# DEVELOPMENT REVIEW COMMITTEE (DRC) CITY OF ROCKWALL, PLANNING & ZONING DEPARTMENT

Project Number: SP2019-031

Project Name: Site Plan for 259 Ranch Trail

### **Project Plan Review History**

## LANDSCAPE PLAN

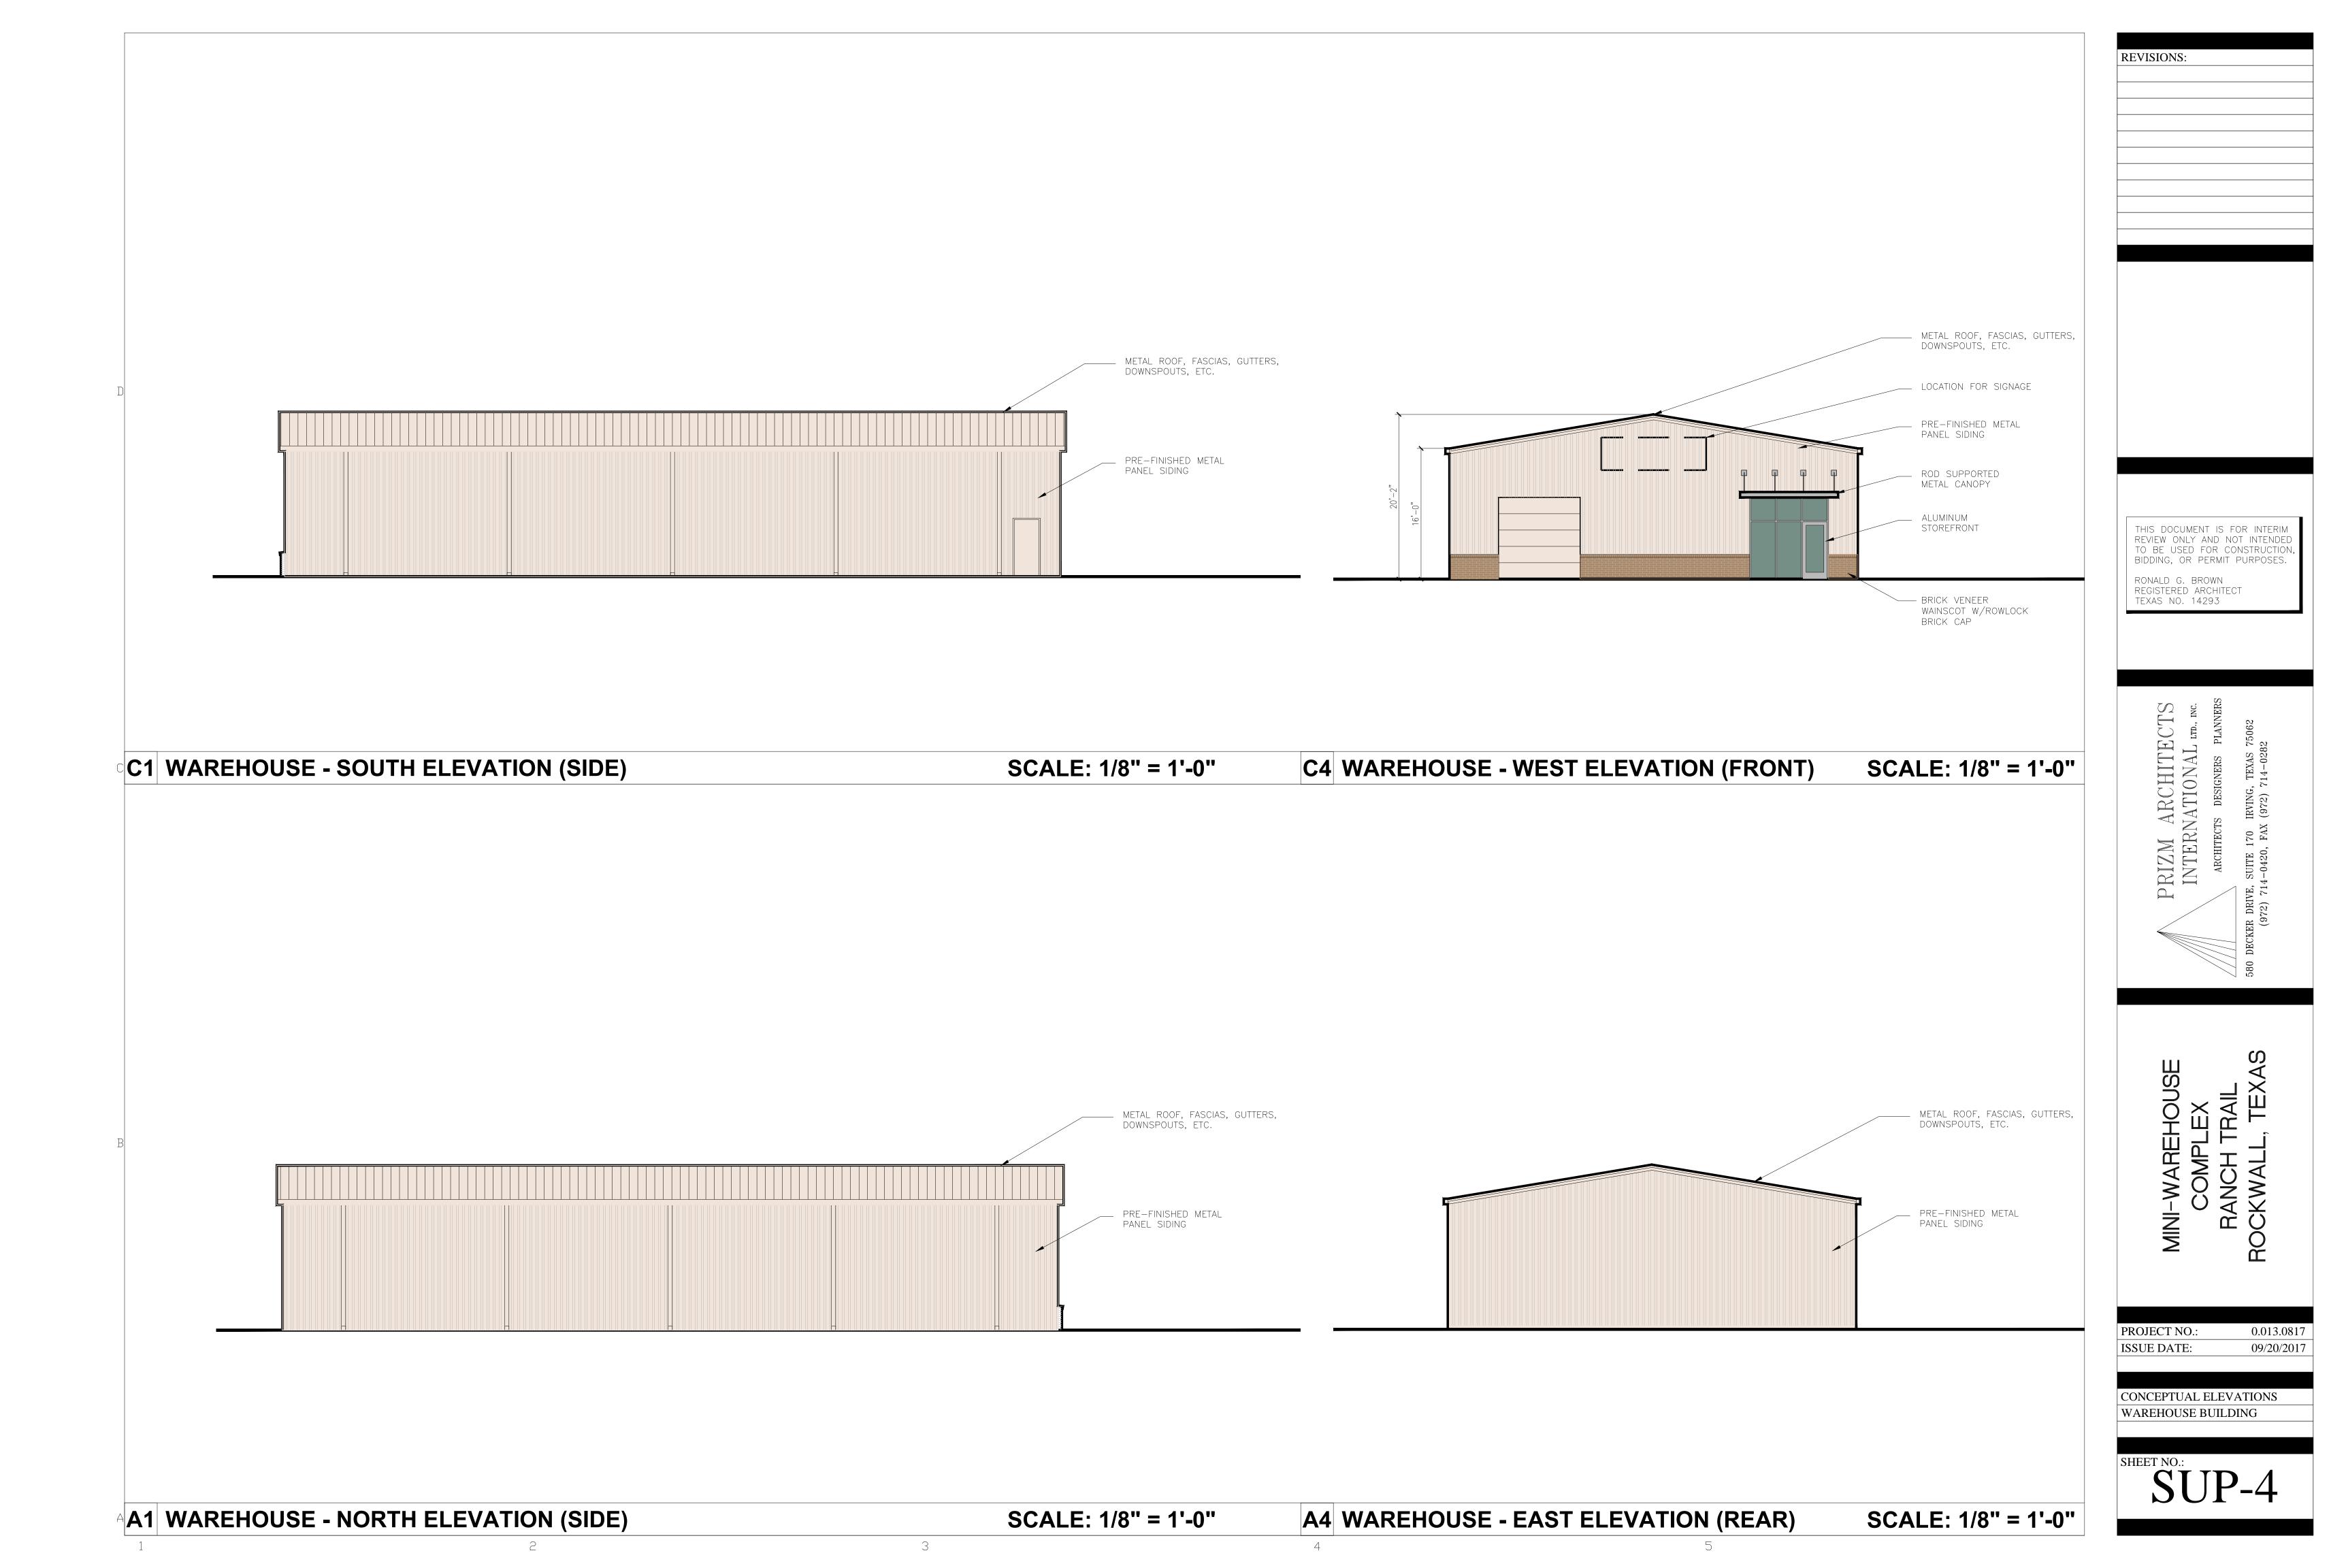
- 1) Please note that that the existing metal building will need to be removed in order to construct the proposed building.
- 2) Please check with the Engineering Department to ensure that the proposed driveway meets the driveway spacing requirements.
- 3) Please note that all of the existing asphalt will need to be removed and replaced with concrete conforming to the Engineering Standards of Design in the Municipal Code of Ordinances.
- 4) Please provide pavement materials and thickness
- 5) In order to prevent trees from interfering with the overhead utilities, please provide accent trees in the landscape buffer adjacent to Ranch Trail Road and move the canopy trees to the interior.
- 6) Please note that outside storage is prohibited

M.7 Site Plan. No equipment screening shown. According to Subsection 1.05, Screening Standards, of Article V, District Development Standards, of the Unified Development Code (UDC), utility equipment and air conditioning units shall be screened from view from any adjacent street or property utilizing plantings, berms, walls matching the main structure, or an architectural feature that is integral to the building's design. Please show and label how the mechanical equipment will be screened on the existing building and the proposed building.

M.8 Dumpster Enclosure. No detail of the dumpster enclosure was provided. According to Subsection 1.05, General Standards, of Article V, District Development Standards, of the UDC, trash and recycling enclosures shall be screened by a minimum six (6) foot tall, solid masonry dumpster enclosure that utilizes the same masonry materials as the primary building and incorporates an opaque, self-latching gate. Please provide the required detail.

## LANDSCAPE PLAN

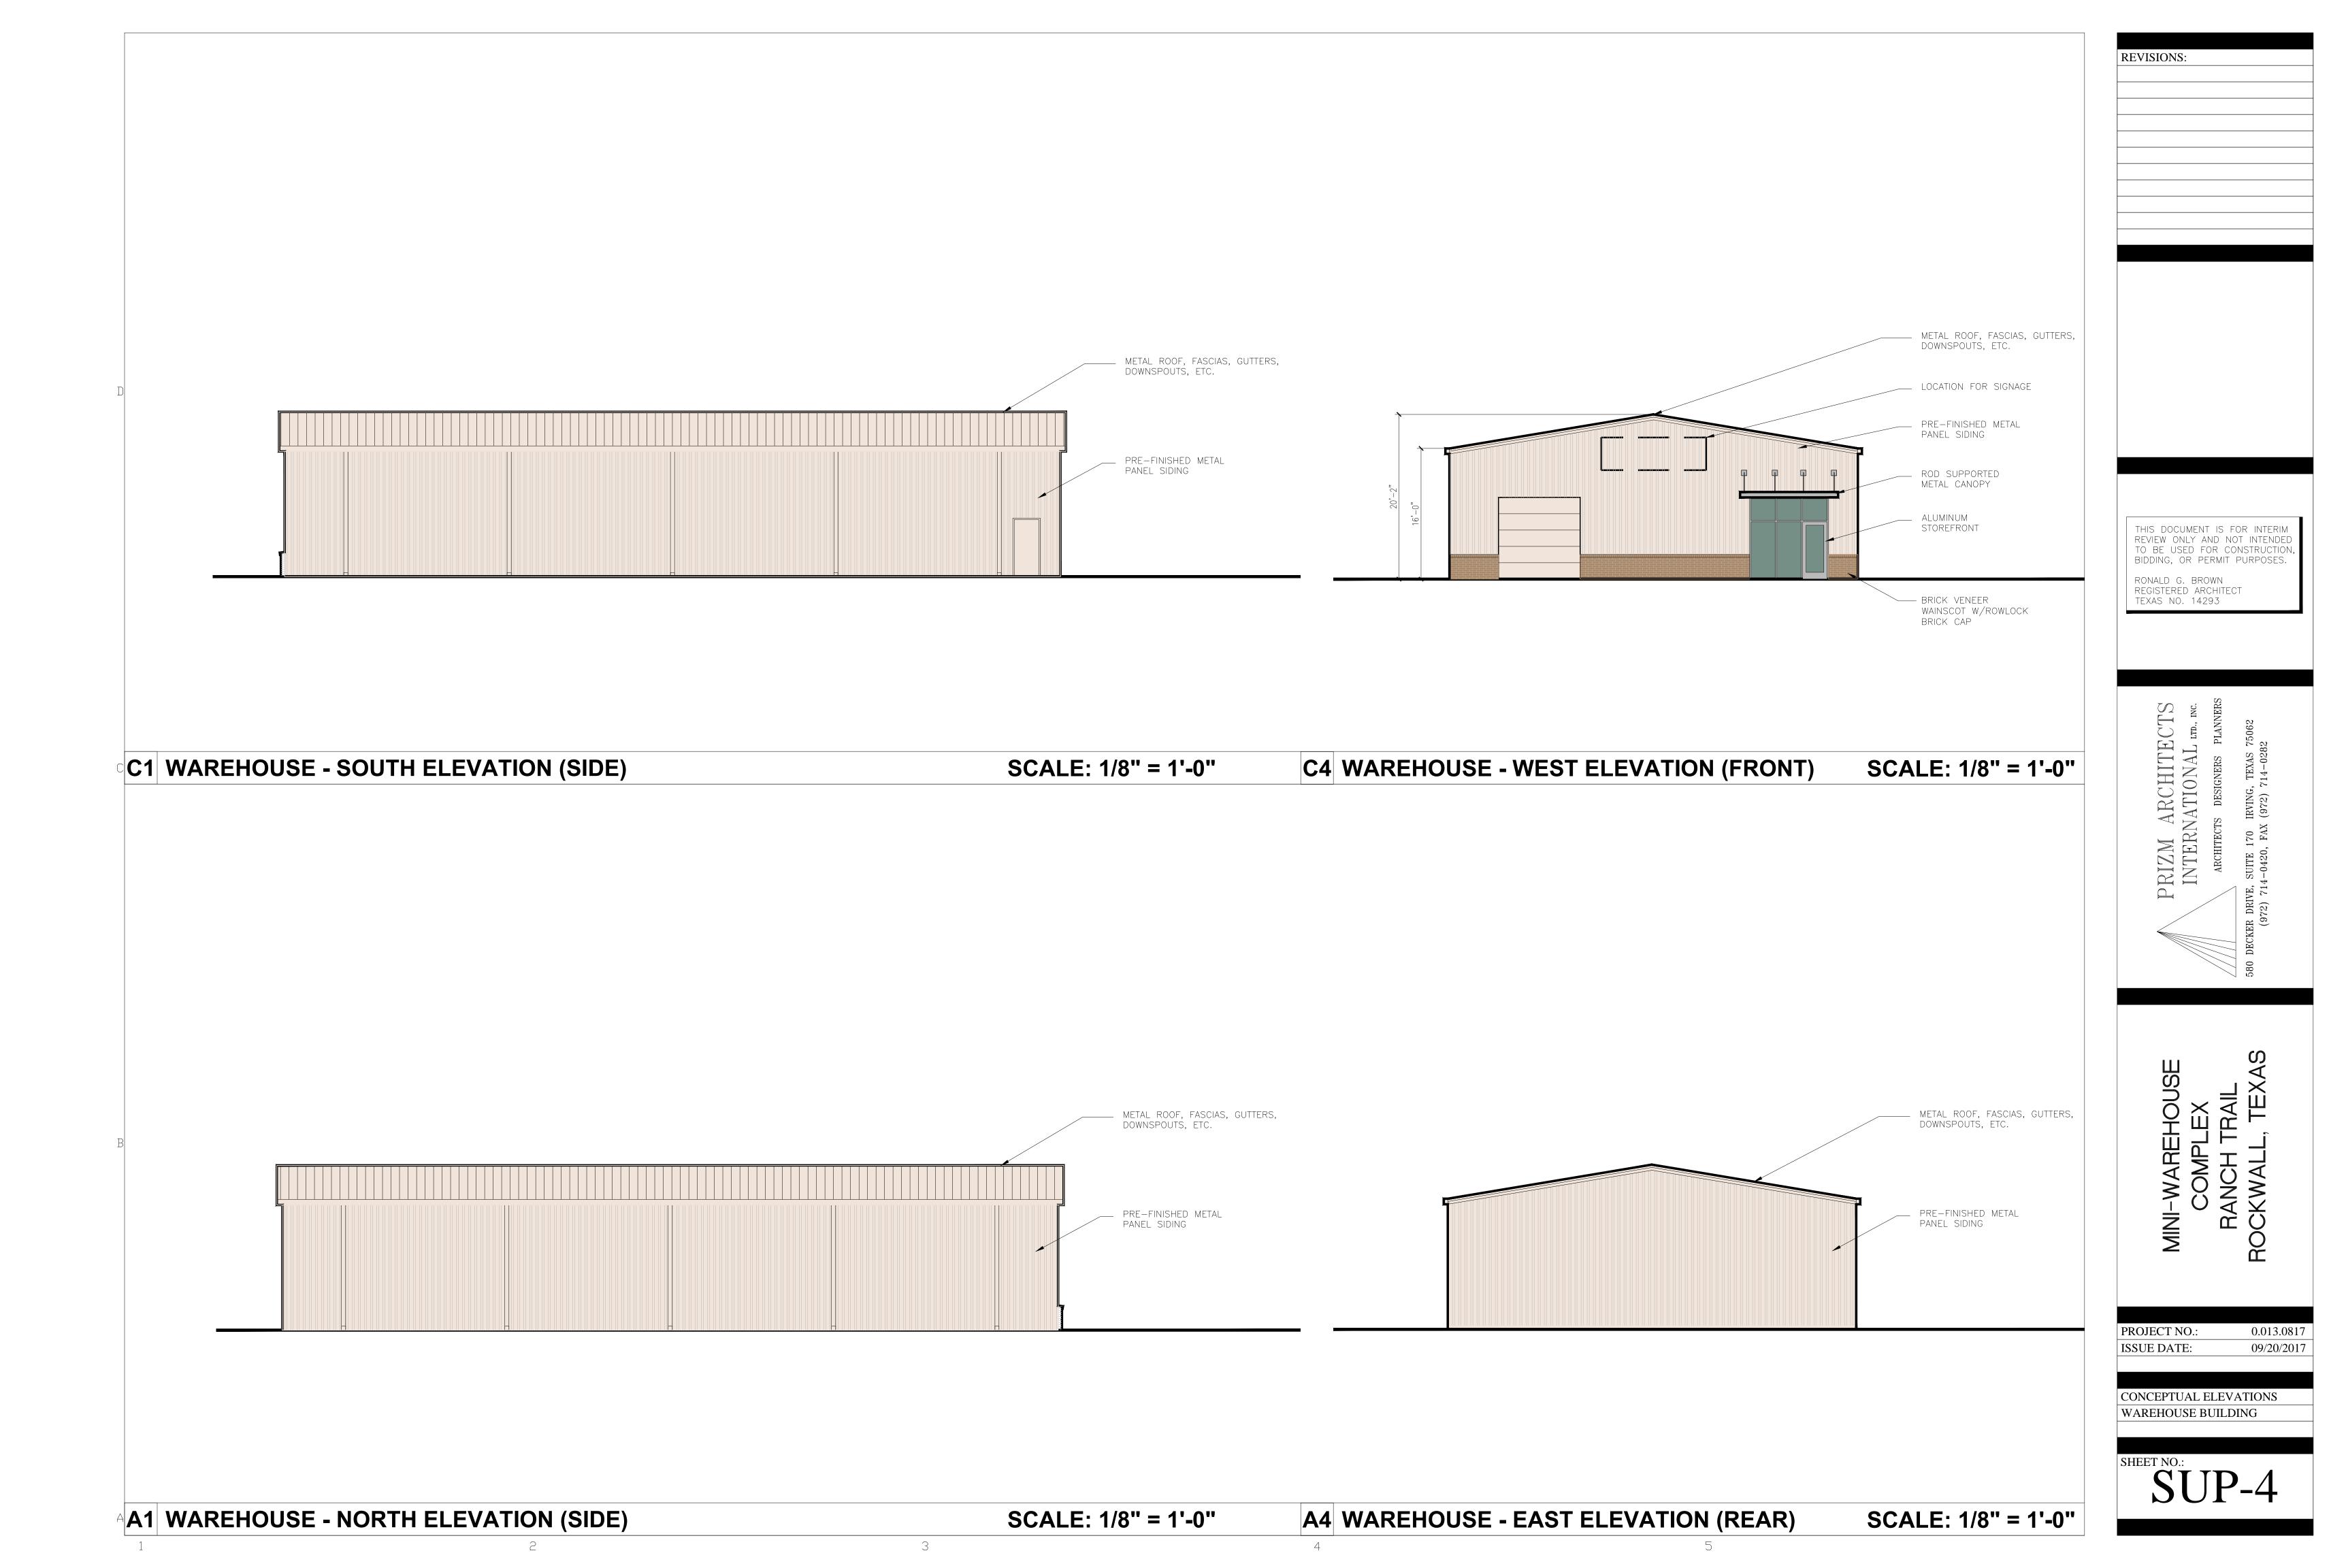
(a) Maximum Wall Length. Subsection 4.01, General Commercial District Standards, of Section 4. Commercial District, of Article V, District Development Standards, of the Unified Development Code (UDC), stipulates that the maximum wall length shall not exceed more than three (3) times the wall's height without a recess or projection of an architectural element. In this case the maximum wall length is approximately 48-feet; however, the length of the north and south facade of the proposed metal building will be 110-feet and will not utilize a projection, recess, or architectural element. Since this exceeds the maximum wall length, an exception to the building articulation standards is required to be approved by the Planning and Zoning Commission pending a recommendation from the Architectural Review Board (ARB). Section 9, Exceptions and Variances, of Article XI, Zoning Related Applications, of the Unified Development Code (UDC), gives the Planning and Zoning Commission the ability to grant an exception to the building articulation standards where unique or extraordinary conditions exists or where strict adherence to the technical requirements of the Unified Development Code (UDC) would create an undue hardship. In cases where an exception is being requested the applicant is required to provide a letter to staff outlining [1] the reason for the exception being requested, [2] the unique or extraordinary conditions that exists, and [3] the proposed compensatory measures (e.g. increased landscaping, masonry building materials in percentages equal to or greater than the surrounding properties, etc.). The applicant has provided staff with a letter outlining the proposed compensatory measures; however, did not provide [1] the reason for the exception being requested or [2] the unique or extraordinary circumstance that exists. In this case, the Planning and Zoning Commission is tasked with reviewing the proposed compensatory measures and determining if additional compensatory measures are necessary to offset the exception being requested.

### Exhibit A

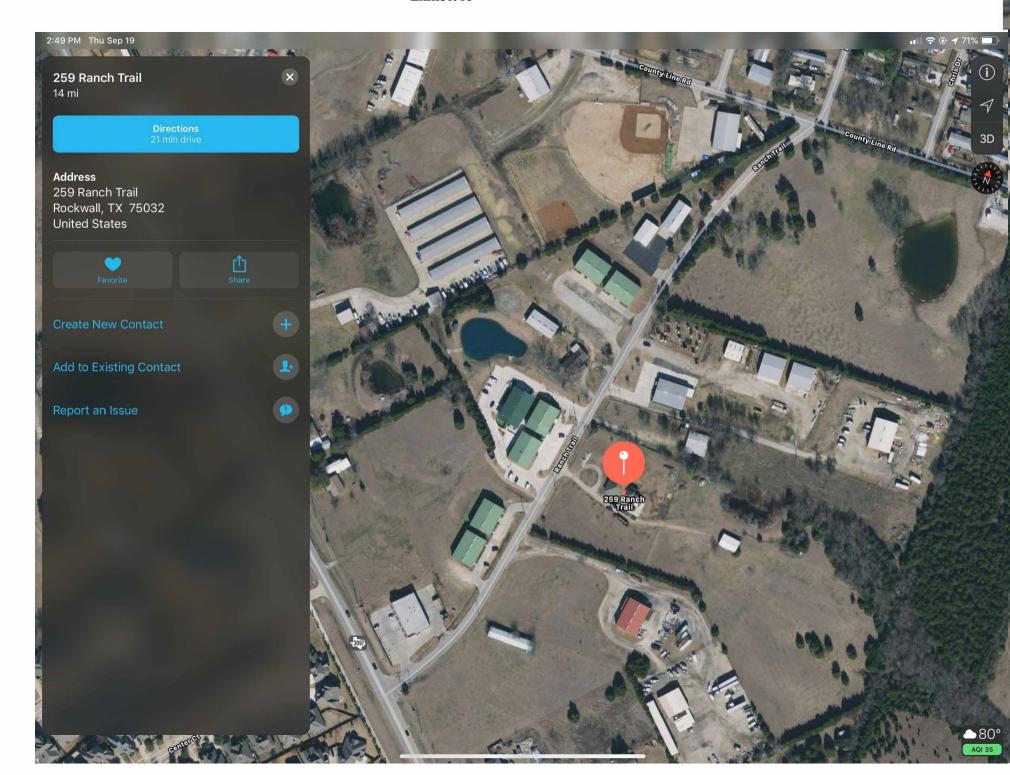
Furthermore, Exhibit A, aerial view shows all the existing buildings do not meet the articulation standard.

In addition to providing the two compensatory measures, our argument is per our exhibit, we are requesting to be consistent with the other businesses on the street, all of which do not meet the articulation standards.
